Item 20-15 Proposal to include new parking sign in the CA MUTCD

Requesting Agencies/Sponsor: Caltrans/Monica Kress-Wooster, CTCDC member

Figure 2B-24 (CA). Parking and Standing Signs and Plaques (R7 Series) (Sheet 1 of 3)

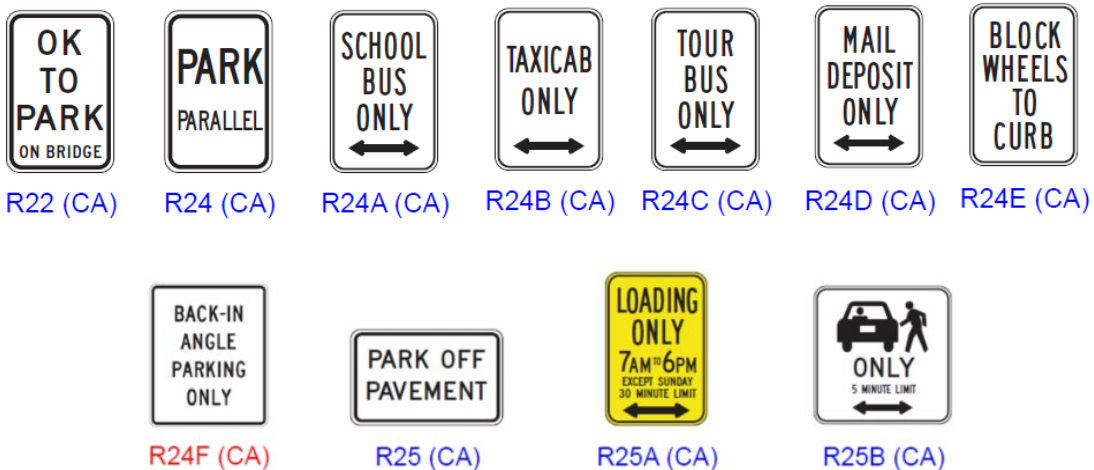
Proposal: The CA MUTCD does not have a sign to address back-in angle parking. Adding this proposed sign to CA MUTCD will support the diagonal parking stall markings. Back-in angle parking enhances the safety of the bicyclists sharing the road with vehicles parked in the direction of travel. Back-in angle parking also enhances the safety of the driver and passengers to enter or exit from vehicle.

^{14a} If supported by local ordinance, the "BACK-IN ANGLE PARKING ONLY (R24F(CA)) sign should be used.
